<b>Title of Change:</b>	Packing quantity increase from 450ea/box to 1350ea/box for TO247&TT3PN
<b>Effective date:</b>	31 Dec 2020
<b>Contact information:</b>	Contact your local ON Semiconductor Sales Office or <a href="mailto:Daisy.Zhi@onsemi.com">Daisy.Zhi@onsemi.com</a>
<b>Type of notification:</b>	This Product Bulletin is for notification purposes only. ON Semiconductor will proceed with implementation of this change upon publication of this Product Bulletin.
<b>Change Category:</b>	Test Change
<b>Change Sub-Category(s):</b>	Shipping/Packaging/Marking

文書番号: PB23734X

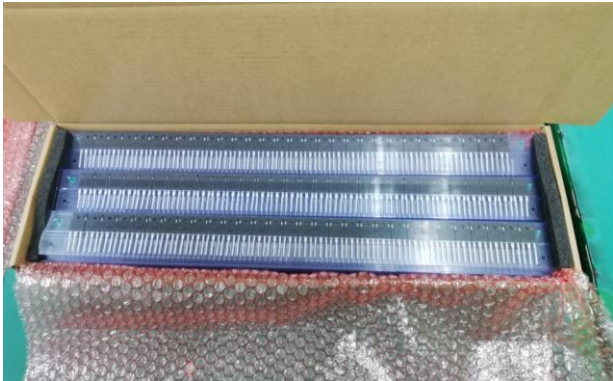
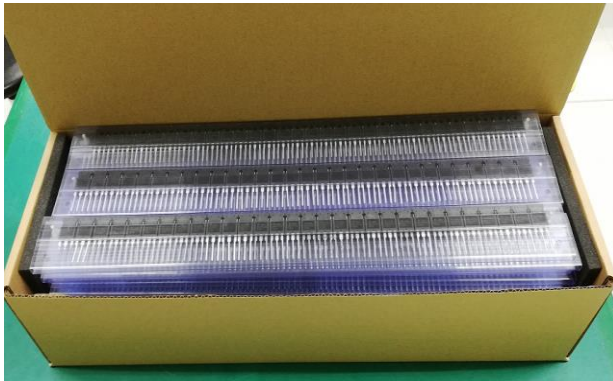
TT3P/ TO247	Quantity per box	
	Current	Proposed
MPQ	450 units	1350 units(remove the bubble bag fill)
<b>Entity Photos</b>		
<b>Stack Floors</b>	5	15

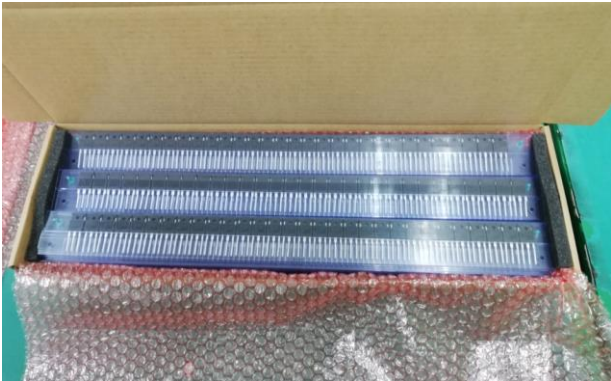
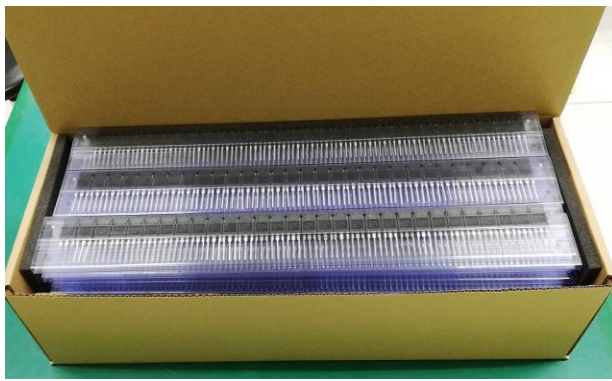
TT3P/ TO247	1 箱あたりの数量	
	現行	変更案
MPQ	450 個	1350 個(気泡緩衝材を取り除く)
実際の 写真		
スタック フロア	5	15
